Re: Resubmission letter  
Town Project No. 2021-07  
Serviss Subdivision  
1298 Union Avenue  
SBL: 14-1-48  
R2 Zone  
Job No. 20244-HHS

The following is our response to Town of Newburgh Planning Board Review comments for meeting date May 6, 2021 (Project #2021-07) in order of comments;

**PROPOSED 2 LOT SUBDIVISION ENTITLED SERVISS**

DATE	SCALE	JOB NUMBER	SHEET NUMBER
04/01/2021	1"=30'	20244-HSS	2 OF 4

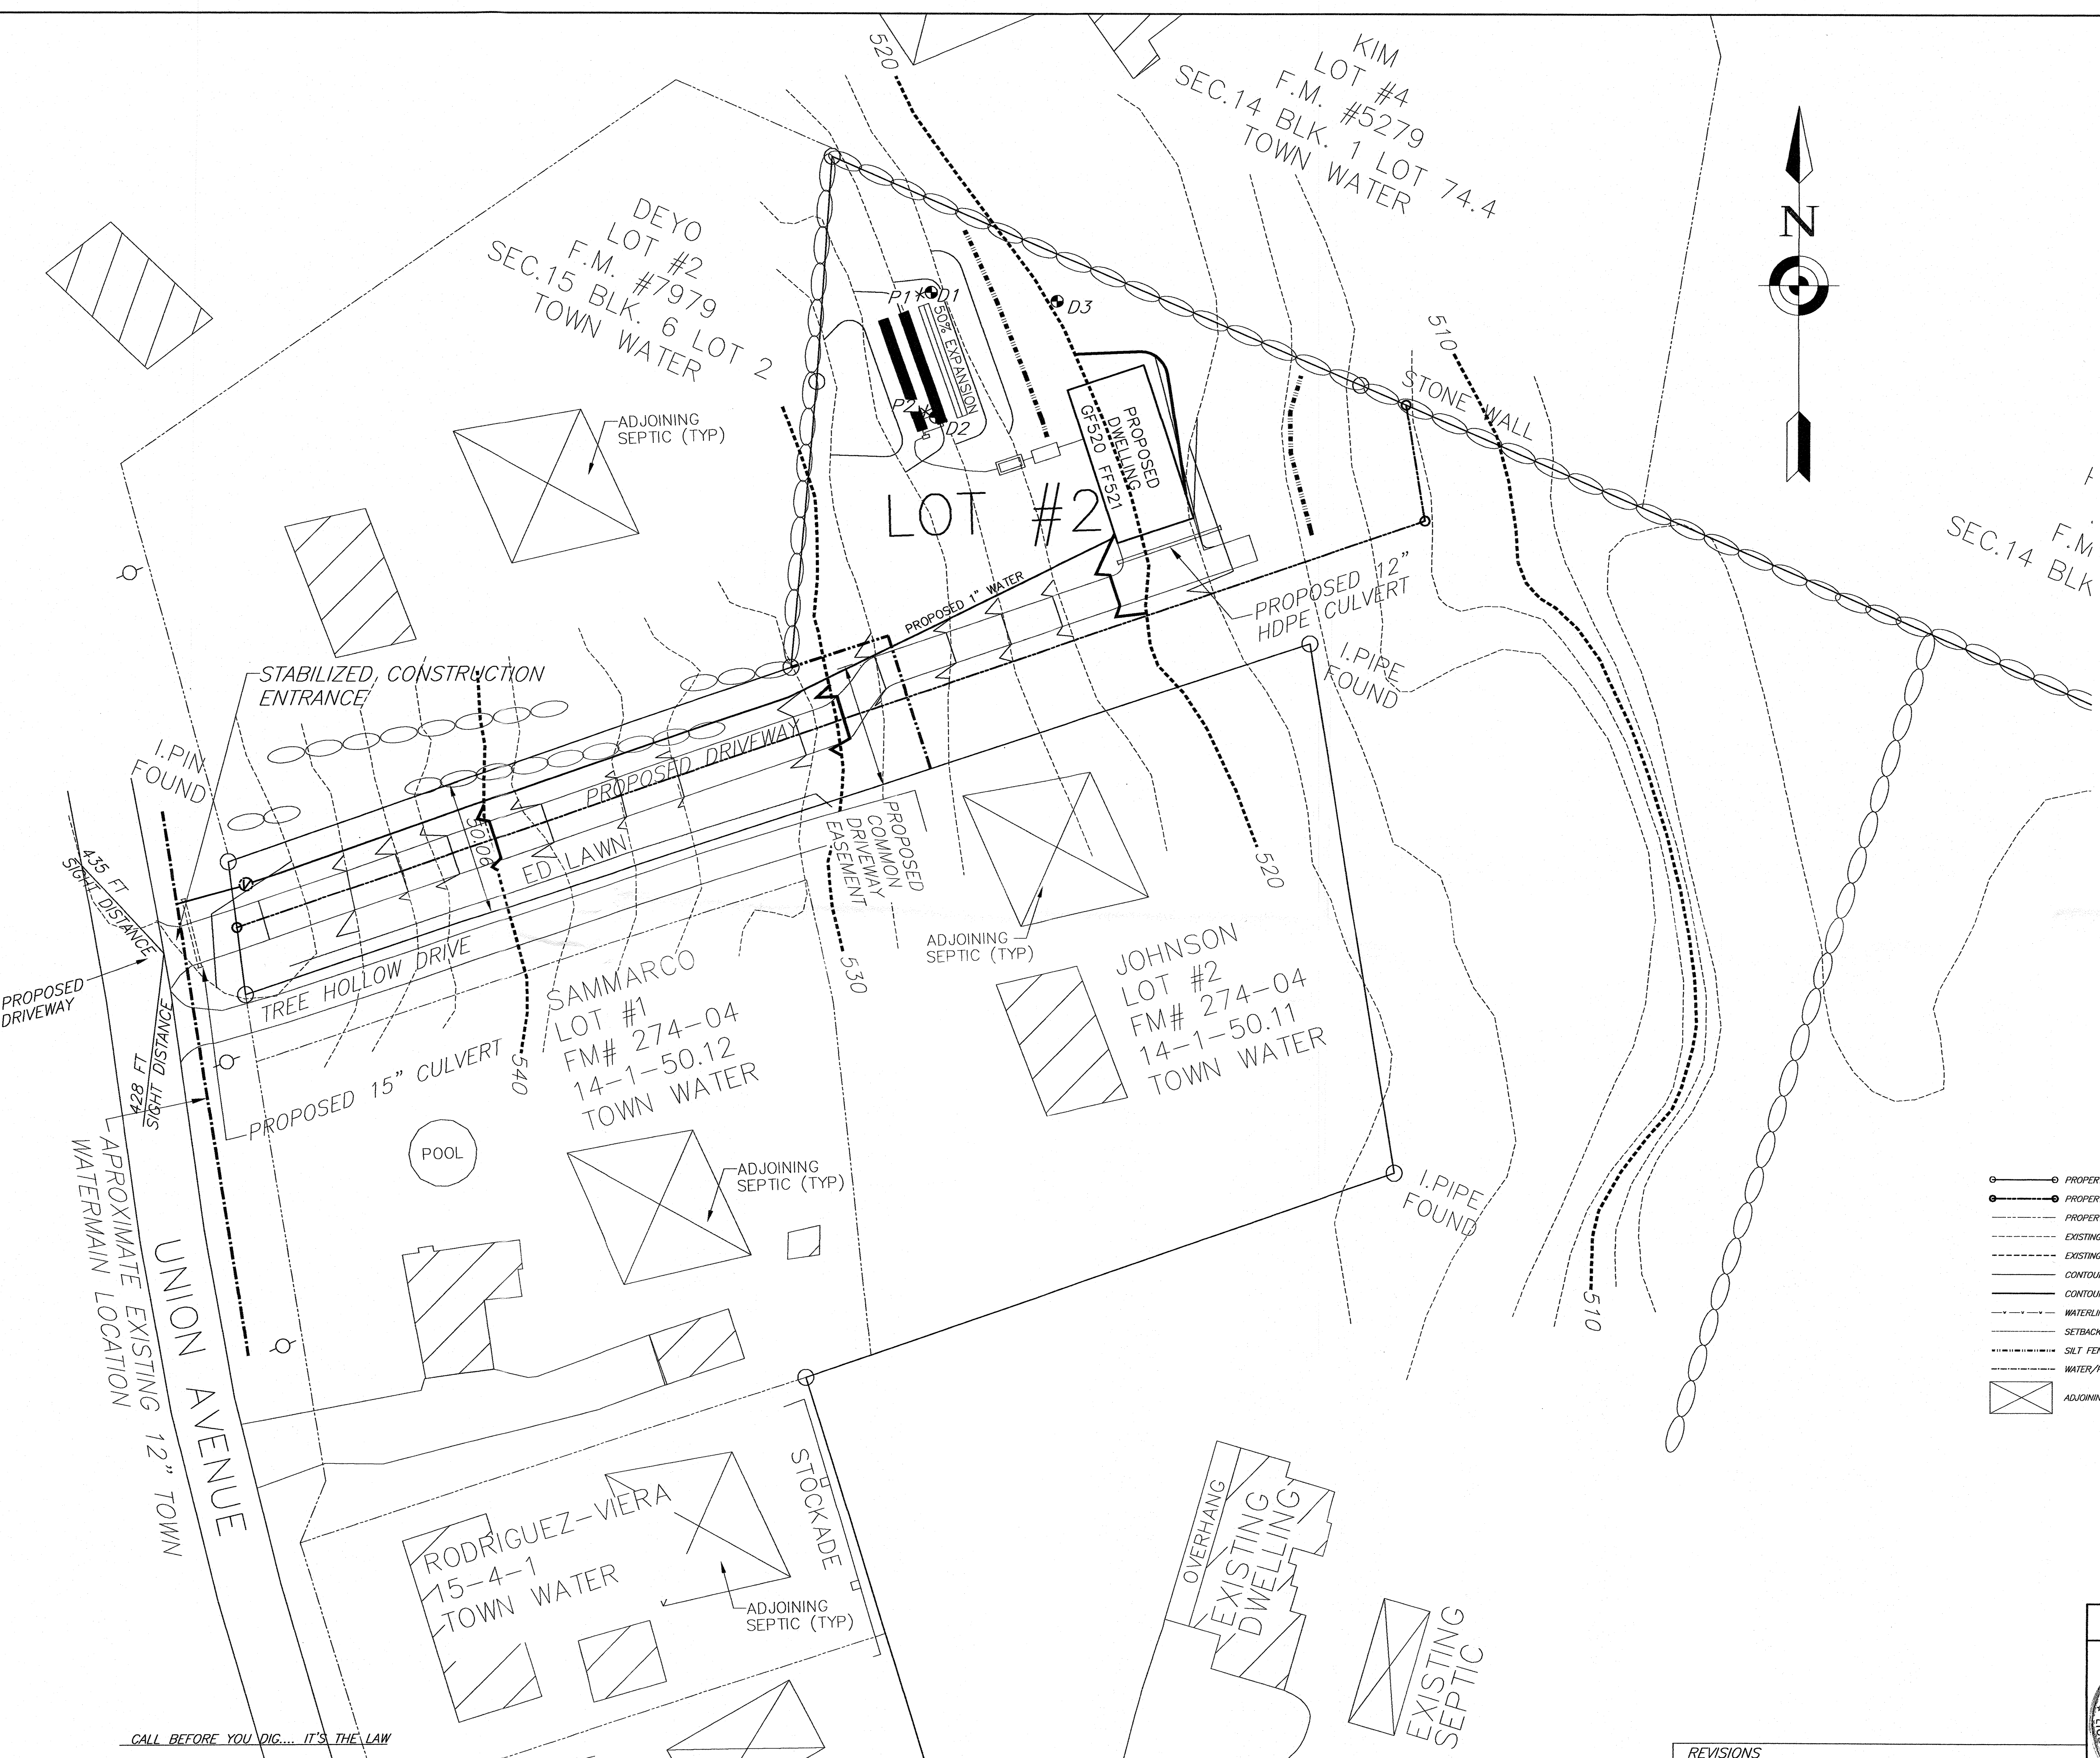
- 1) A set of plans has been sent to the Highway Department and the driveway location has been marked out in paint.
- 2) Location map revised.
- 3) Bulk table revised.
- 4) Proposed water service added to sheet 2.
- 5) Proposed driveway grading added to sheet 2.
- 6) Proposed driveway grading with swales added to sheet 2.
- 7) No response required.
- 8) Revised owners added to sheet 1.
- 9) No response required.
- 10) Adjoining items with 200'.
- 11) Combined entrance has been added to sheet 2.
- 12) Proposed serviced line size has been added to sheet 2.
- 13) Water system notes have been revised on sheet 4.
